#59-F-239-C
HWY. #32
GANANOQUE
RIVER CROSSING

Estimated Settlements - Cananogue River Bridge
Highway #12, near Cananogue, Ont.

Gananoque River Crossing
Hwy. No. 32 - Proposed Revision Line C

SKETCH SHOWING ESTIMATED PRESSURE DISTRIBUTION BELOW ABUTMENTS
(Theories of Elasticity and Plasticity - Boston Soc. of Civil Engineers, 1925-1940, P.173)

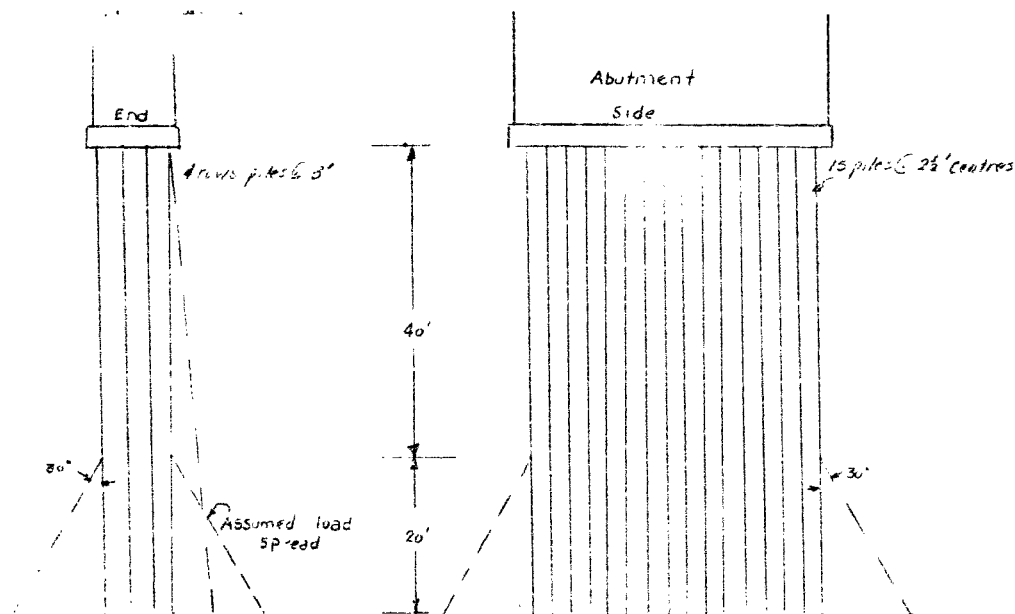
Scheme 1: Assume: Earth pressure for triangular loading condition as shown in Dwg. 1.
 60 piles founded at Elev. 205 ft., or about 60 ft. below river bed level.
 4 rows of 15 piles, $2\frac{1}{2}$ ft. centres, with rows 3 ft. apart.
 Approx. dimensions of pile group = 10 ft. wide by 39 ft. long.
 Settlement, from abutment load, occurs below lower third of pile group, or below El. 225 ft.
 30° load spread from pile group into underlying soil.

NOTE: Actual settlement of piles due to abutment weight and fill pressure below Elev. 225 feet = 11 ins., or about 50% of this movement. The compression of the clay above Elev. 225 ft. has been added to this because any tendency of the upper clay to settle more than the piles will cause additional load to be thrown into the pile group. This in turn will cause the pile group to settle more. The computations for this condition have not been included.
